FC-01 — REVISE RACEWAY SUPPORT LAYOUT

Supports - Proposed Change

Project number	ST-001	FC-01
Date	10/8/26	
Drawn by	Author	
Checked by	Checker	Scale 1/8" = 1'-0"

1 FC-01-Rack Support Layout Review
1/8" = 1'-0"

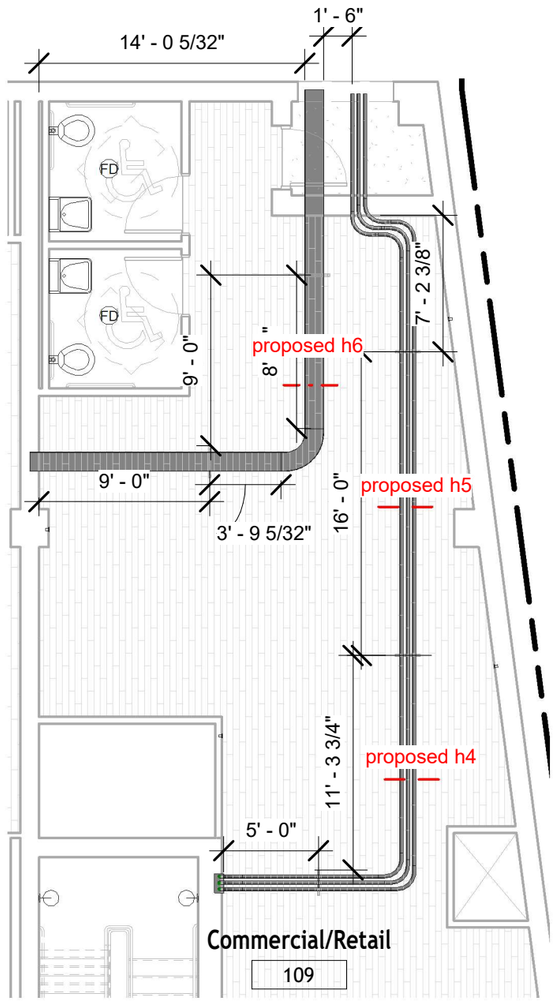
1. Proposed locations are approximate. Dimension final support locations in the revised drawings.
2. Measure hanger spacing center-to-center.
3. Secure EMT at intervals not exceeding 10'-0" and within 3'-0" of boxes and terminations.
4. Cable-tray straight-run spacing: 5'-0" maximum provisional target; verify against manufacturer load/span requirements.
5. For the 90° tray elbow, provide supports within 2'-0" of each fitting end and at the midpoint of the curve, unless manufacturer instructions differ.
6. Coordinate supports with structure and adjacent services. Update affected drawings and support quantities.
